Staff Report to the Western Weber Planning Commission

Application Request: Consideration and action on a request for preliminary plan approval of Sunset Equestrian Cluster Subdivision.
Type of Decision: Administrative
Agenda Date: Tuesday, September 12, 2017
Owner: Fieldbrook Taylor Partners, LLC
Authorized Representative: Doug Nosler
File Number: LVS080717

SUNSET EQUESTRIAN Cluster Subdivision

**MATCH LINE
SEE SHEET 2**

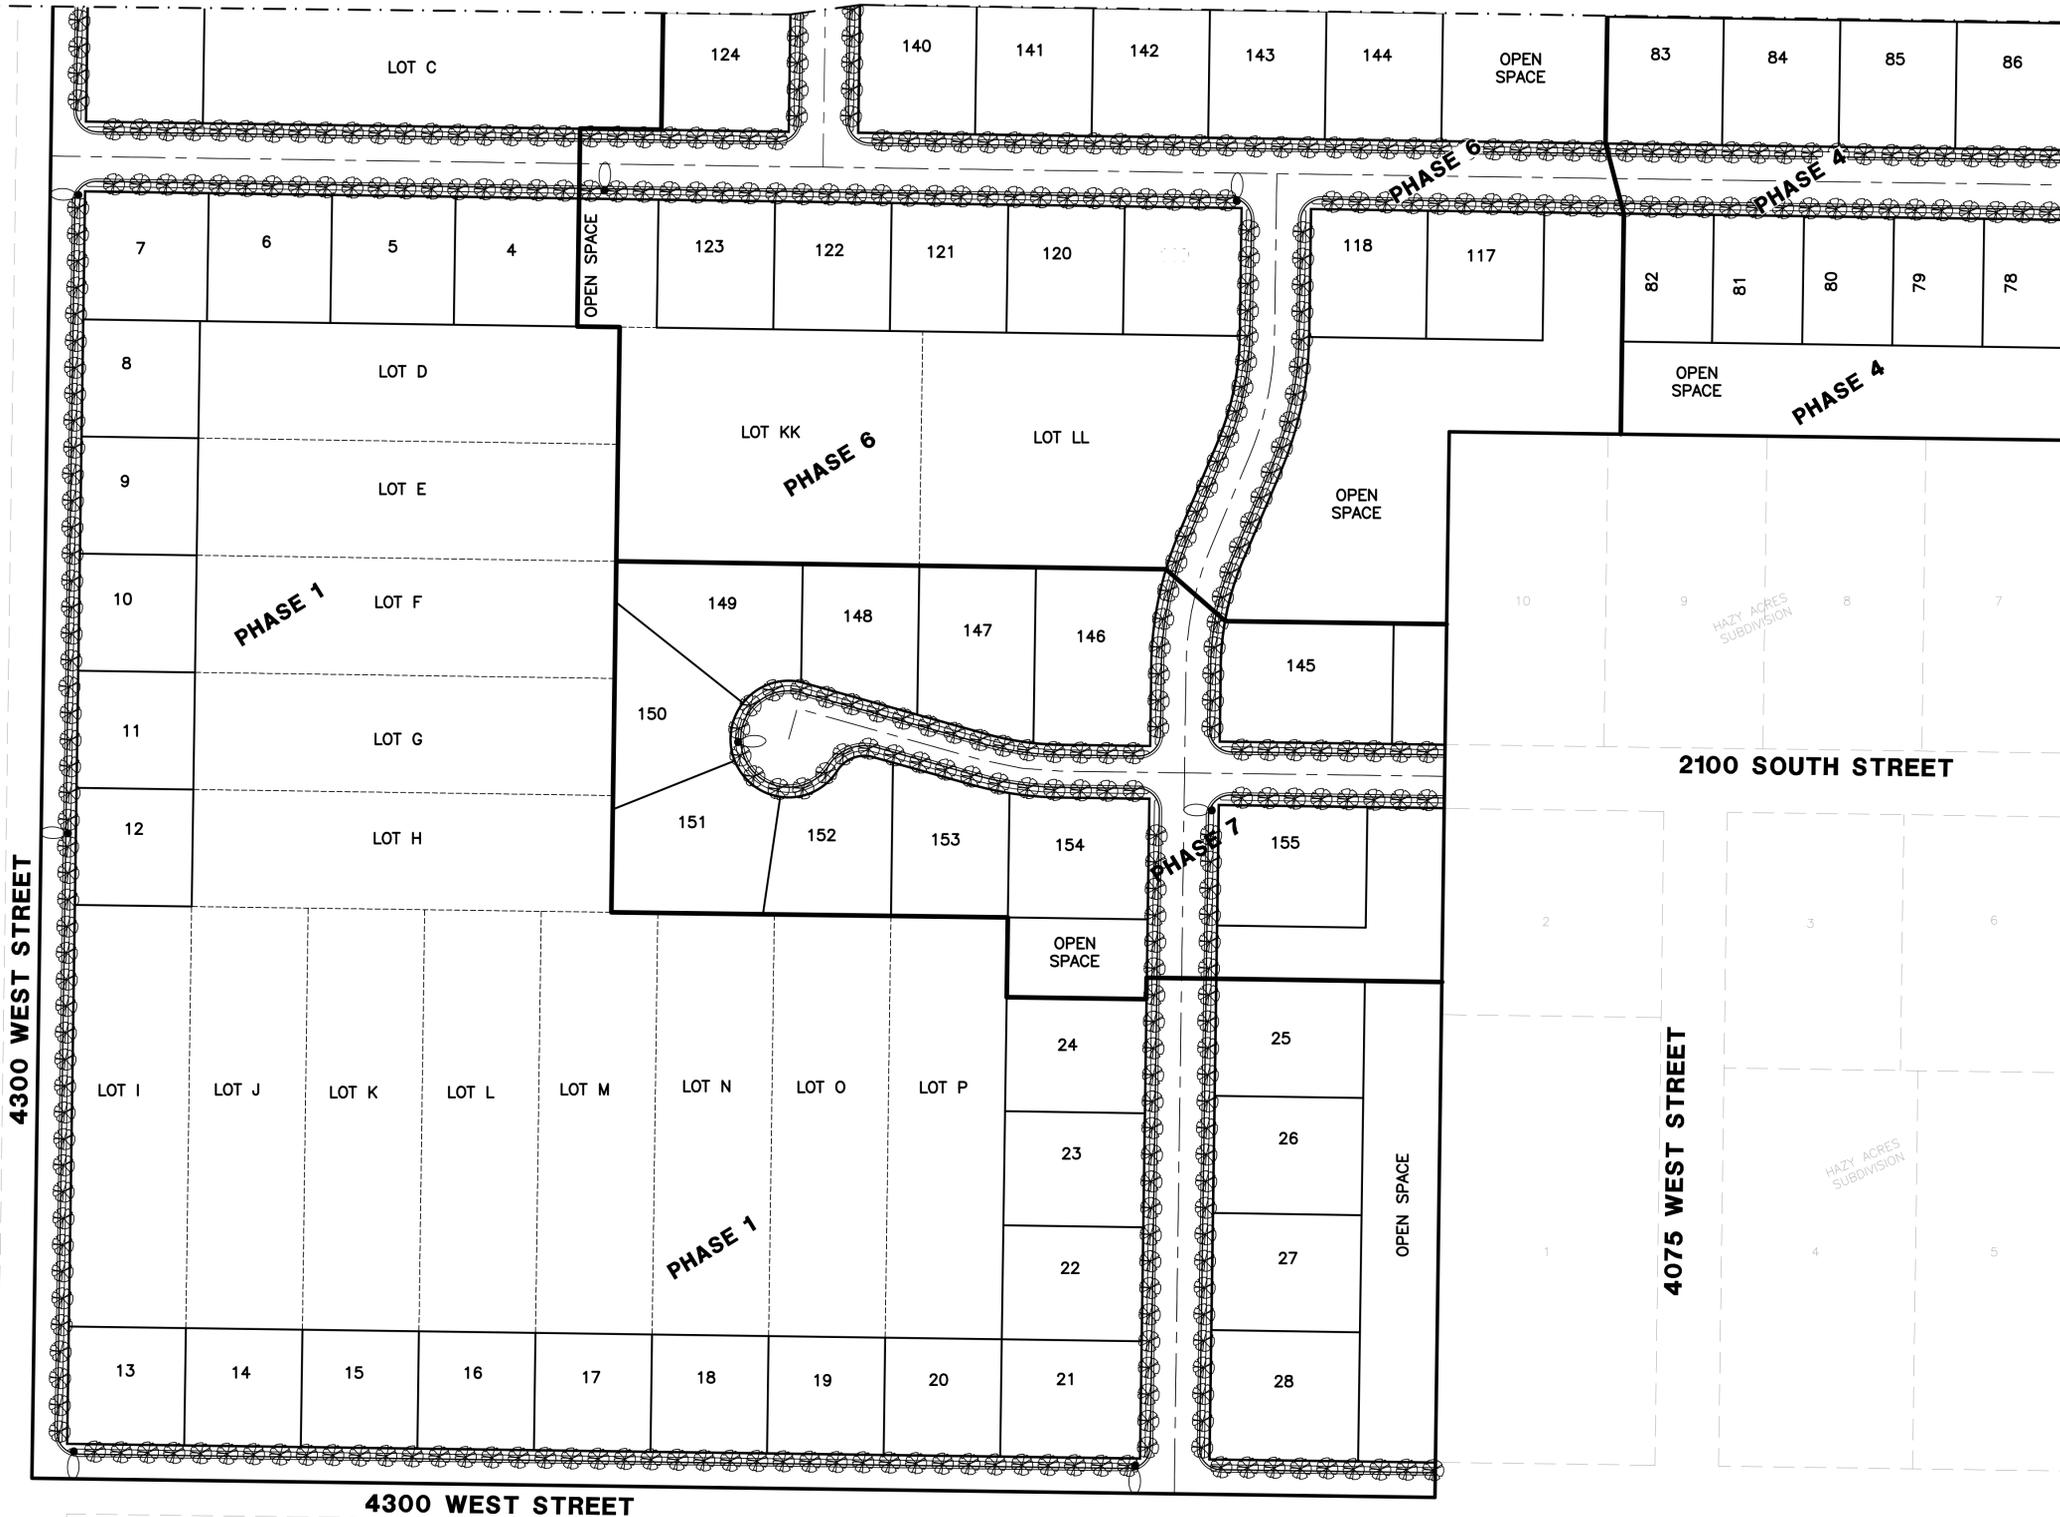
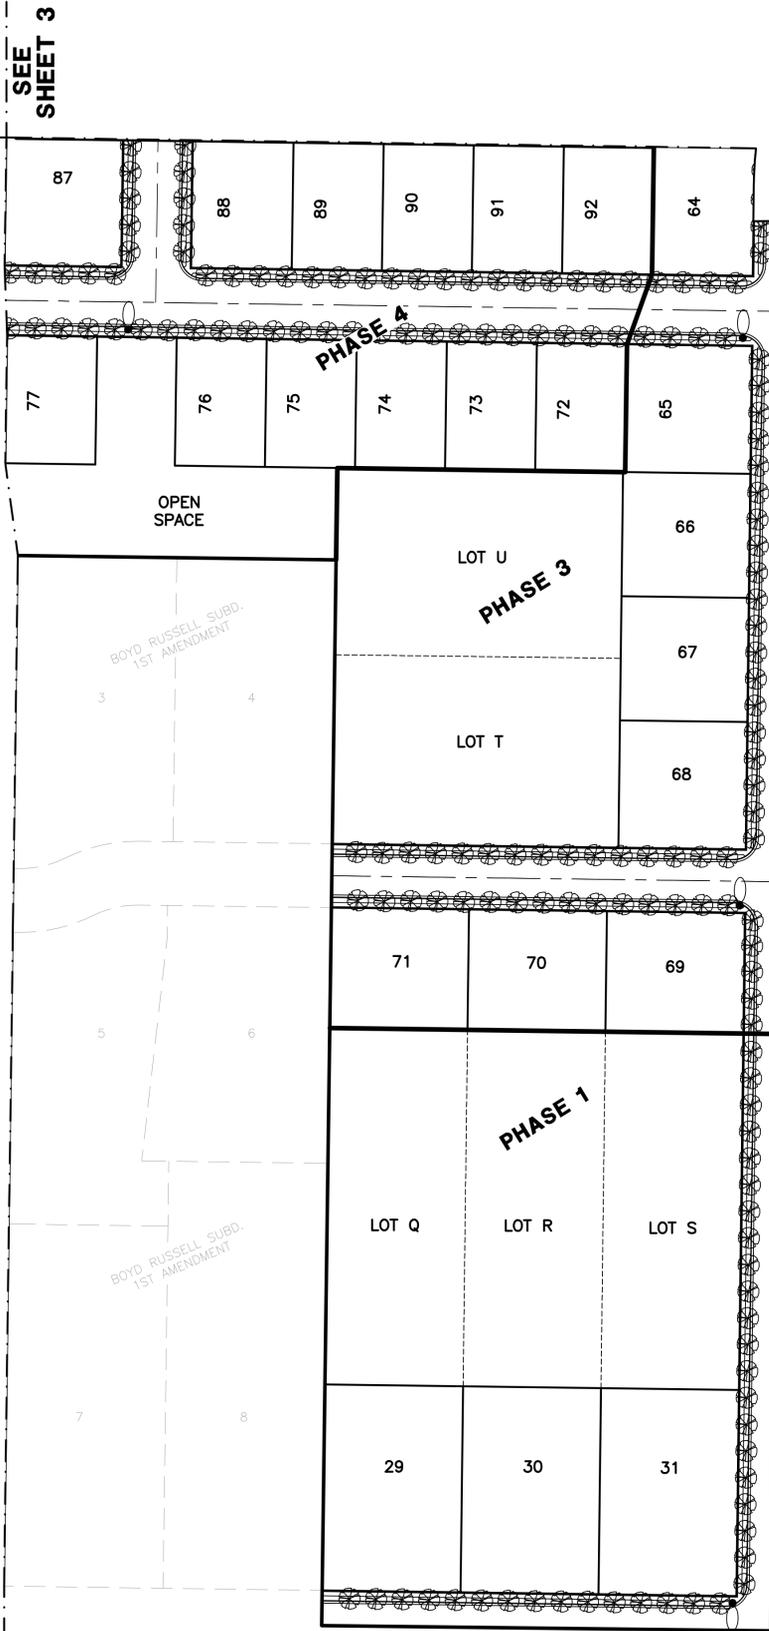
The applicant has provided a roadway landscape and design plan (Exhibit B) including street lights and street trees of the correct caliper, which will be planted according to §108-3-8 (b).
